1 Products affected

The inscription at the socket of the fuse holder changes. SEV and SEMKO symbol are no longer on the socket.

FAU					0118.2255	
creation date	created by	release date	released by	notification no.	revision	page
2015-01-13	dislercy	2015-01-16	dislercy			1 of 1

Old inscription	New inscription

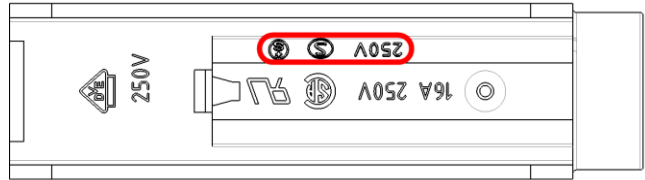
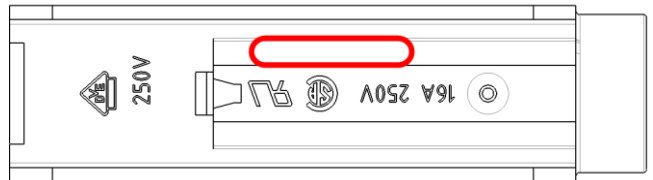
The inscription changes as follows:

Because of the harmonizing of the European fuse holder standards, SEMKO and SEV symbols are removed from the fuse holder socket. The fuse holder FAU is approved acc. to IEC 60127-6 at VDE.
